VILLAGE OF YELLOW SPRINGS
PLANNING COMMISSION
AGENDA

DATE: July 8, 2011
TO: Yellow Springs Planning Commission
FROM: Mark Cundiff, Village Manager
SUBJECT: Senior Apartments PUD

The Village has received an application for PUD-R (Planned Unit Development Residential) approval from Yellow Springs Home, Inc. and Buckeye Community Hope Foundation to develop 37 units of housing for independent seniors aged 55 and older at the property commonly known as the "Barr Property" (321 Xenia Ave.) which is located at the northeast corner of the Xenia Ave./Limestone St. intersection.

S I T E P L A N

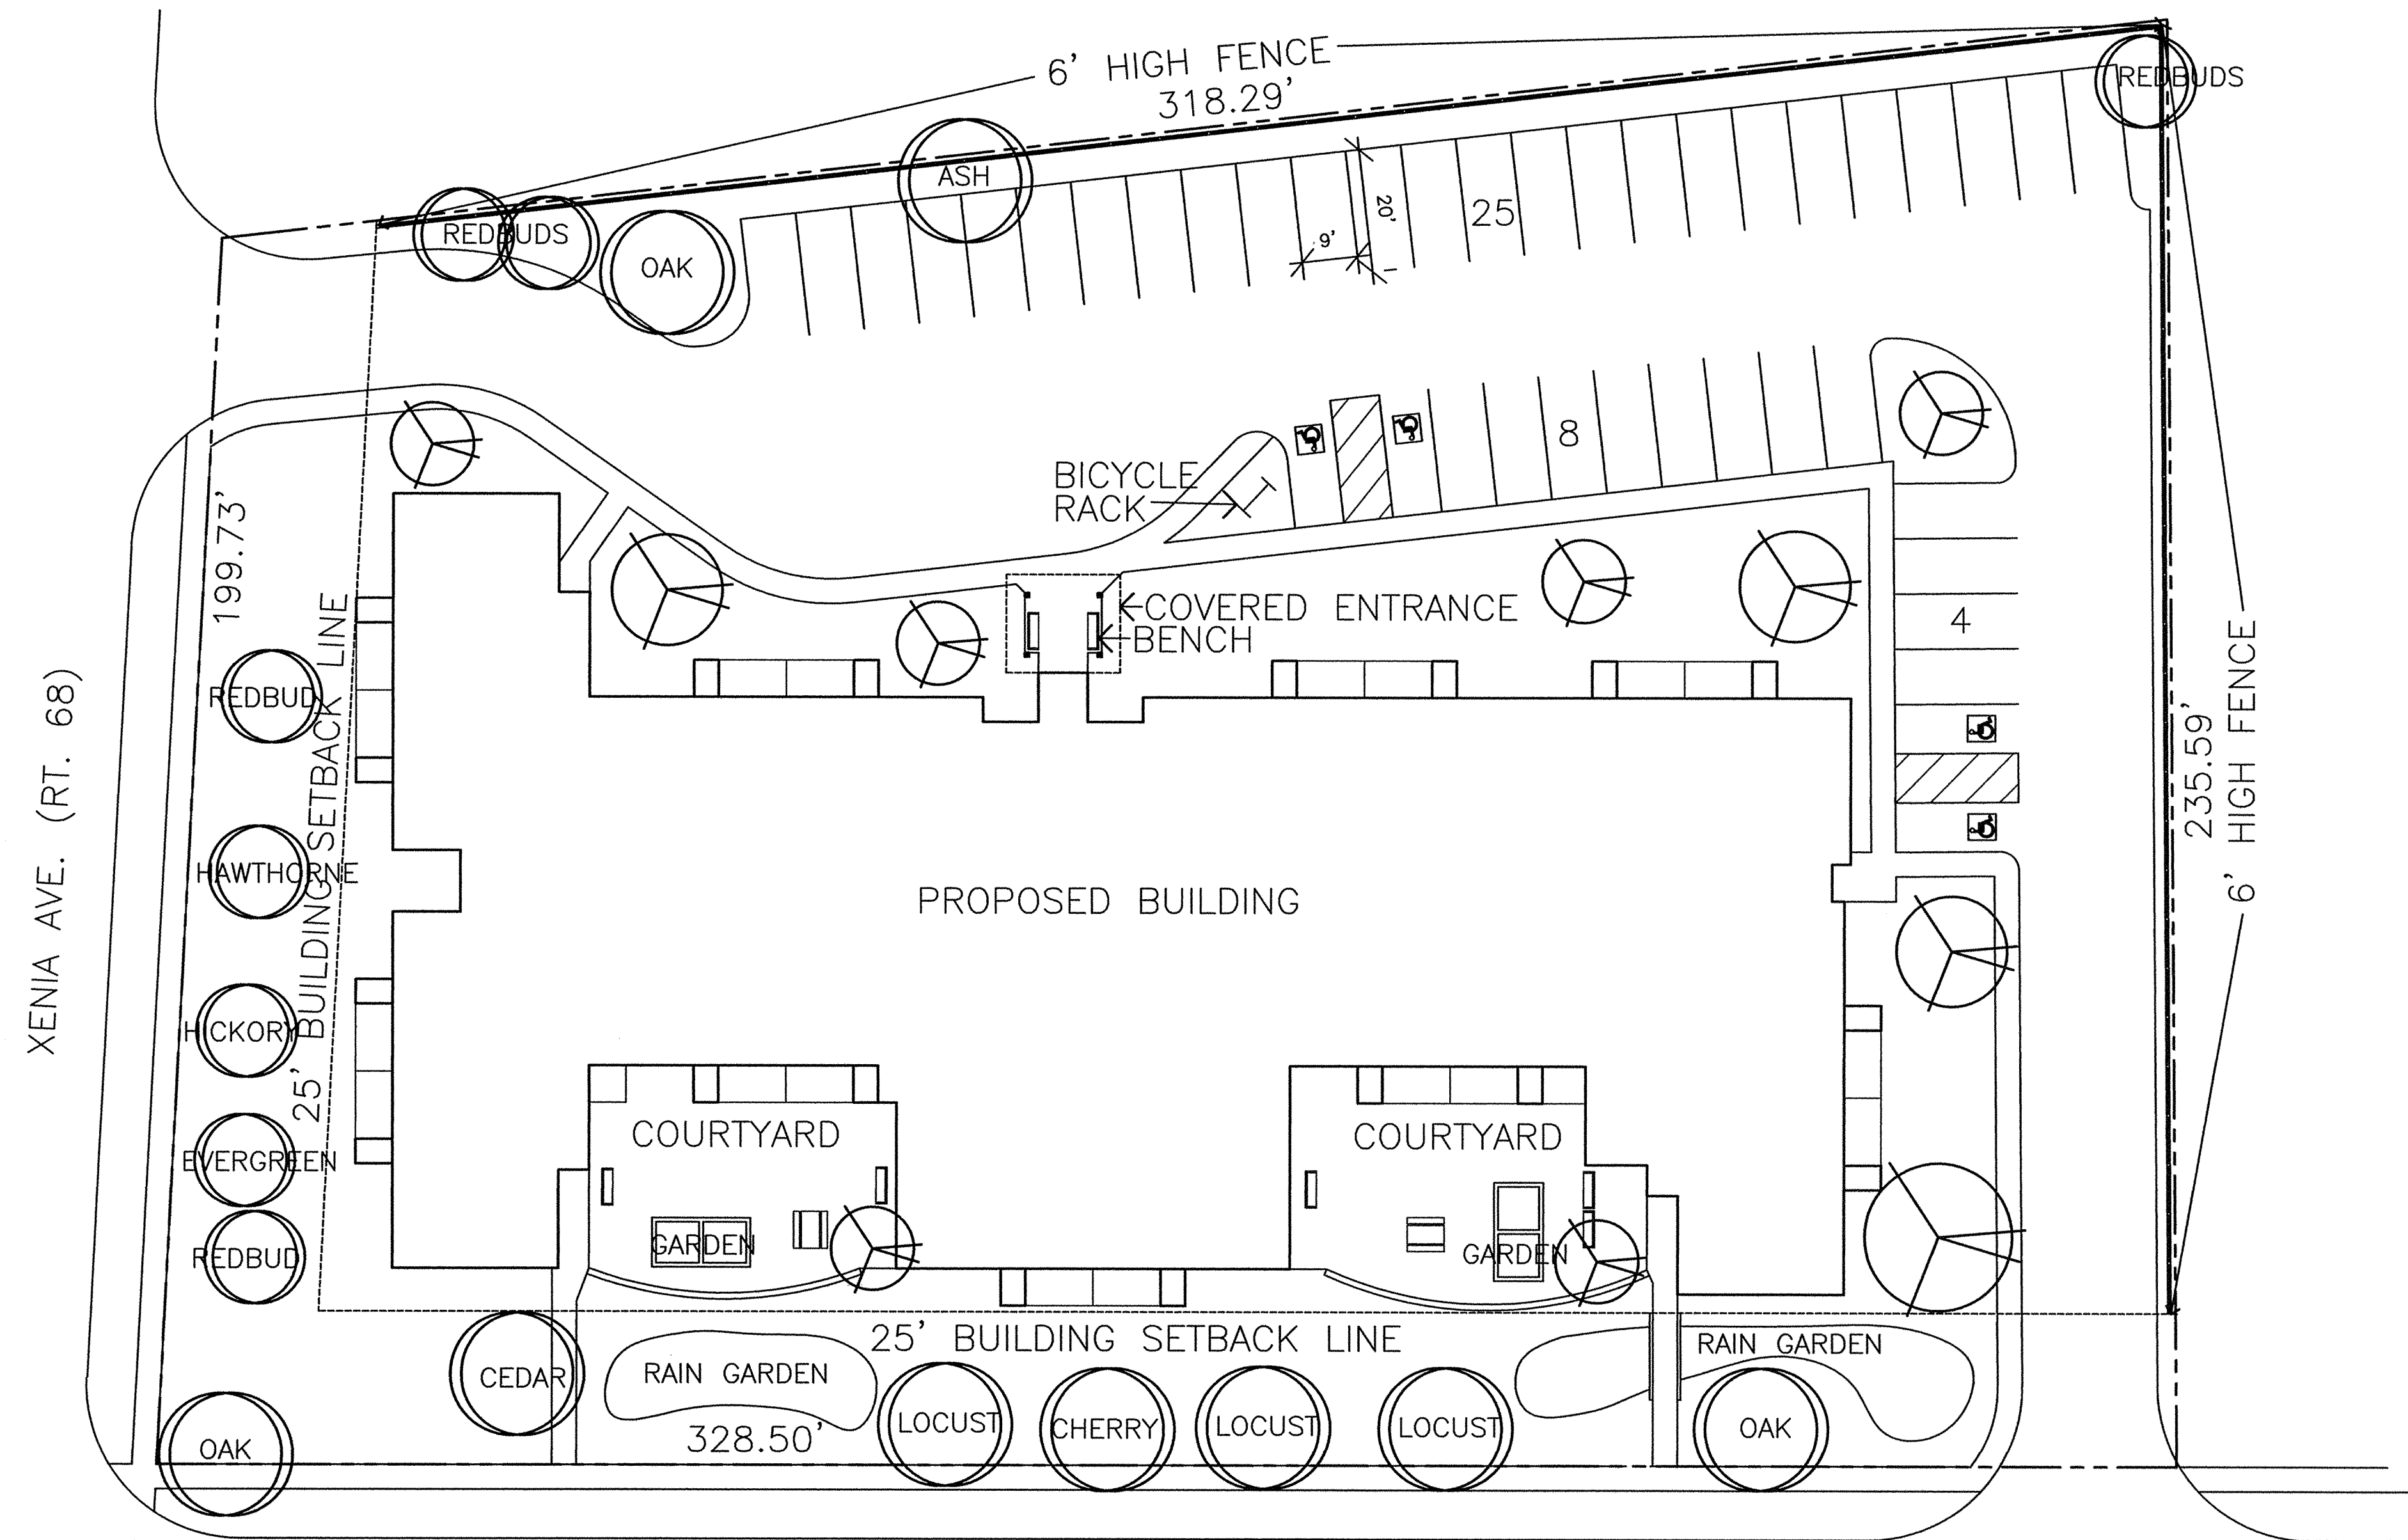
Land covered by impervious surfaces. Land covered by impervious surfaces (building footprints, driveways, sidewalks, parking areas, etc.) shall not exceed 75% of any individual lot within the PUD-R. The property is 1.6 acres which calculates into 69,696 square feet. Therefore, no more than 52,272 square feet (75%) can be an impervious surface. My calculations indicate that there is approximately 46,861 square feet of impervious surface. The developers will need to

provide a more accurate accounting since this amount of impervious surface also will be needed to calculate the storm drainage calculations.

Maximum residential density. The residential density for multi-family dwellings in a PUD-R shall not exceed 12 dwelling units per acre. This development proposes 37 units on 1.6 acres which is a density of 19.2 units per acre.

- Minimum number of spaces for multifamily housing for the elderly is 1.0 space per dwelling unit. This PUD proposes 37 dwelling units and provides 37 parking spaces (with four being handicapped spaces).

- Parking spaces shall encompass 162 net square feet and shall be dimensioned to be 9 x 18 feet. This PUD proposes 9 X 20 (180 s.f.) parking spaces.
- For lots with 90 degree parking angles like the one proposed in this PUD, the aisle width shall be a minimum of 24 feet. This PUD proposes a 20 foot aisle width. However, since the parking spaces are two feet longer than required, it effectively has a 24' aisle width.

- When an off-street parking area is located adjacent to a residential lot, there shall be a minimum of 10 feet between the parking area and abutting lot lines and this 10 foot separation shall be landscaped and screened. This PUD provides the separation and proposes the construction of a six-foot high fence to screen the abutting residential property to the east.

1. Dumpster Detail: The plans show the location of a dumpster, but they give no details on what materials will be used to screen the dumpster.
2. Exterior Lighting: The plans do not show the location of any exterior lighting. This will need to be shown, including how they plan to ensure the lighting does not spill over onto abutting properties. A detail of the exterior lights showing the design also would be helpful.

3. Exterior Signage: The location of any exterior signage needs to be shown on the plan and a rendering of the signage needs to be submitted.
4. Storm Drainage: The plan shows the location of two rain gardens, so in addition to the submittal of storm water detention calculations, some specifications on the rain gardens would also be helpful.

5. Bike Rack: The plan shows the location of a bike rack. A detail of the bike rack needs to be submitted.
6. Benches: The plan shows the location of benches. A detail of the bench will need to be submitted.

8. Landscaping: The plan shows the location of new trees, however it does not identify the species of tree. Additionally, the identification of the trees that will be removed needs to be provided.
